Nepean River Pump and Pipeline (SSD_5225) Response to exhibition of Environmental Impact Statement

Nepean River Pump and Pipeline (SSD_5225) Response to exhibition of EIS Additional comments by NSW Office of Water

Nepean River Pump and Pipeline (SSD_5225) Response to exhibition of EIS IQQM Modelling by NSW Office of Water

Figure C2-02A Lake B water Level with different pumping rates

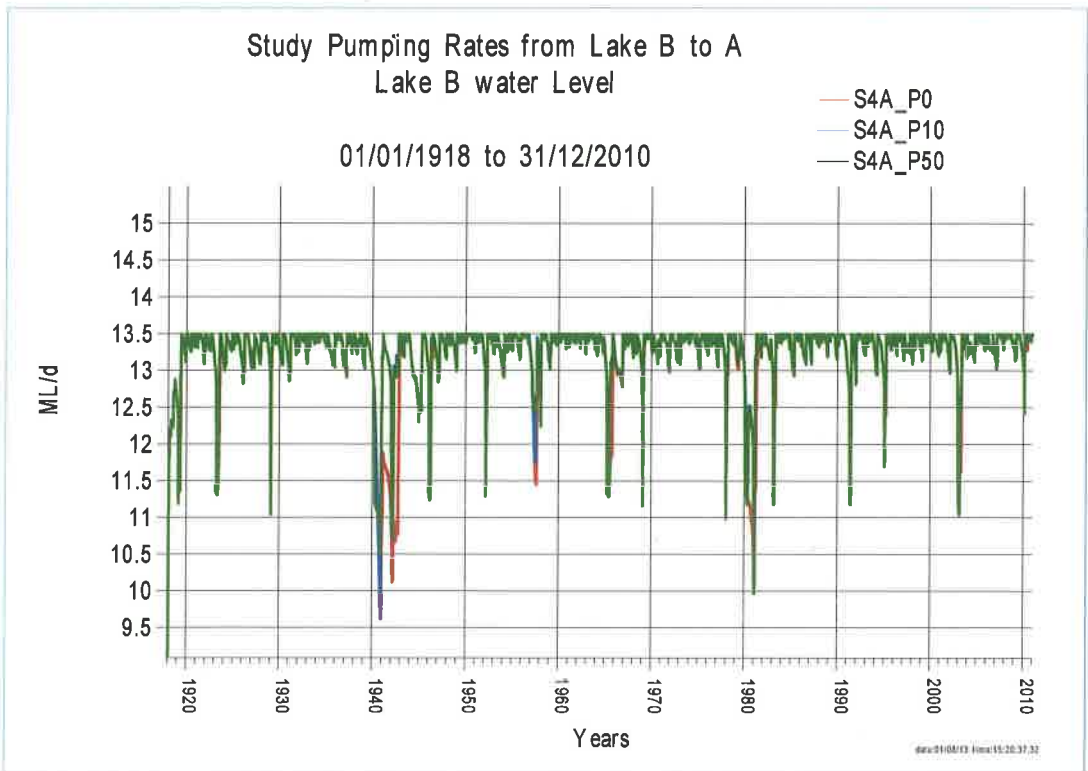
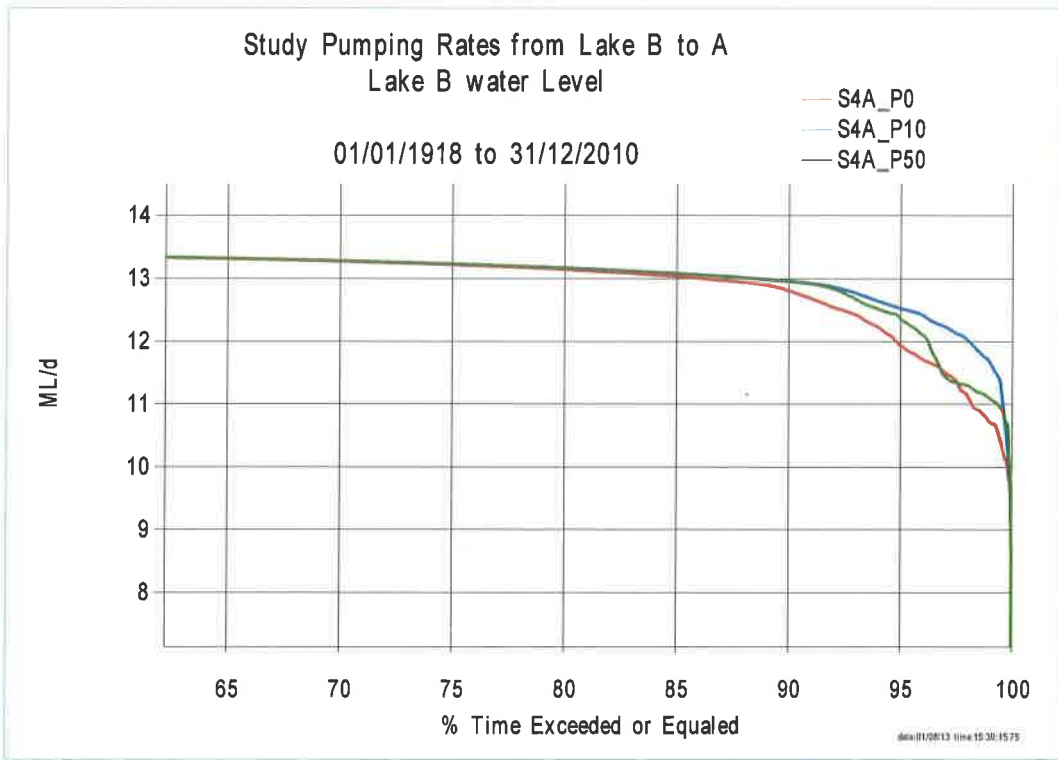
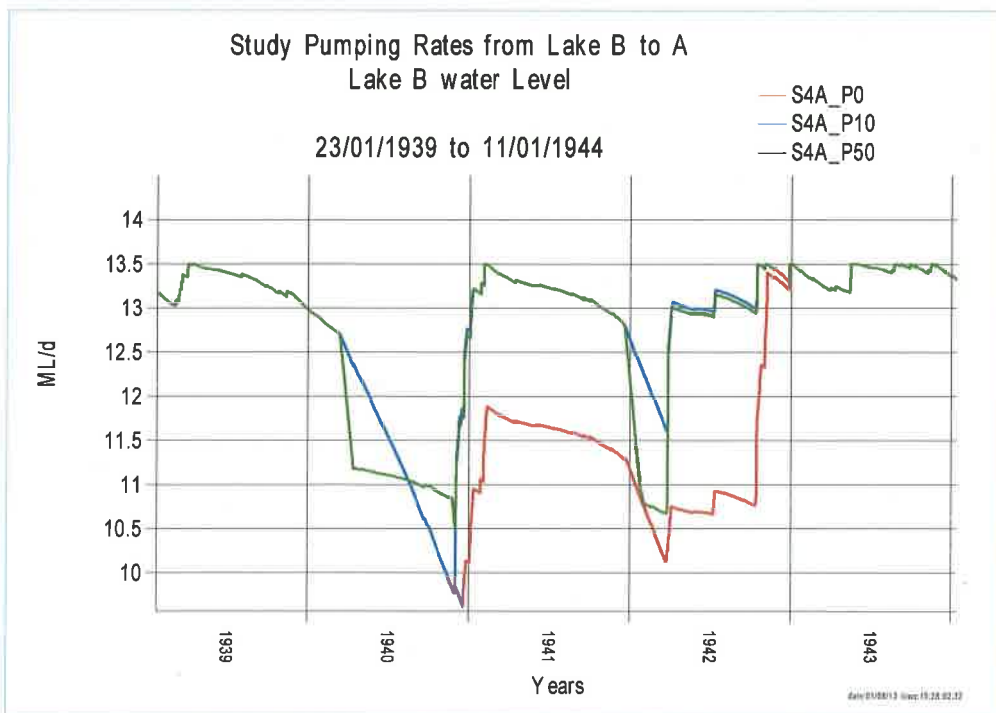
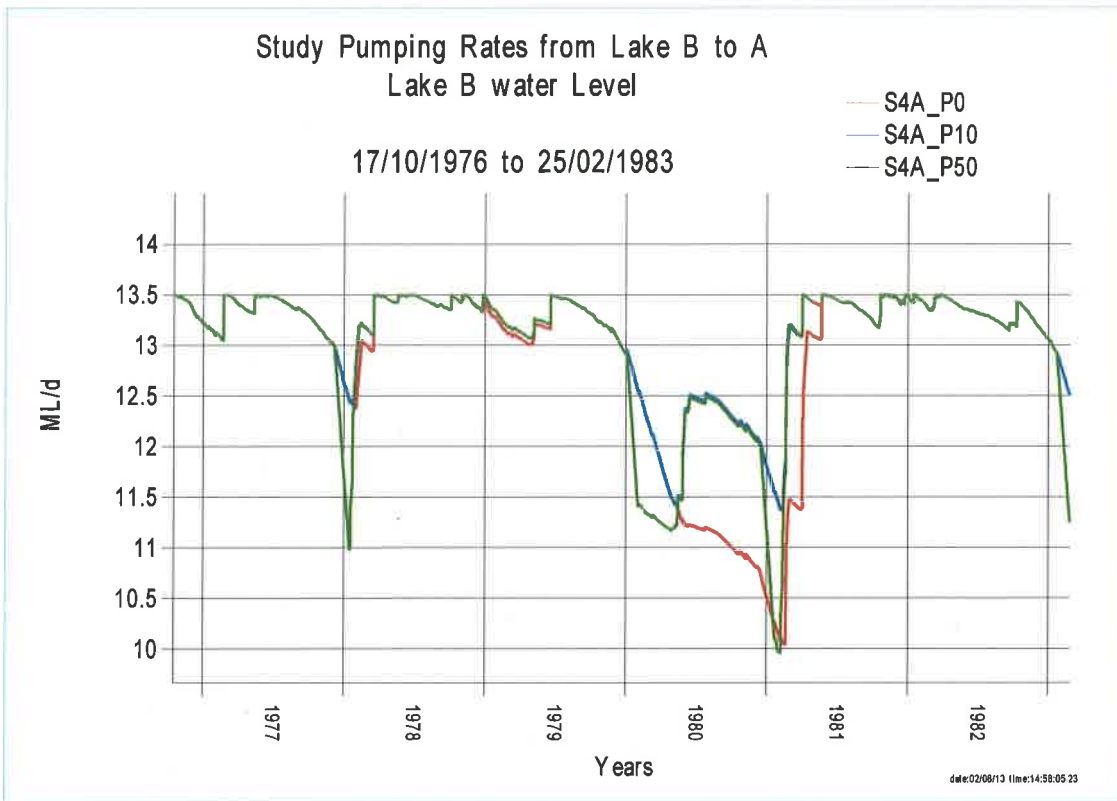
Figures C2-02A to C2-02D show the lake B water level with different pumping rates from Lake B to A. Figure C2-02B show even with no pumping Lake B water level is within 0.5m for about 85% of the time, but Figures C2-02C and C2-02D shows Lake B water level could be well below 0.5m for longer periods in dry weather.
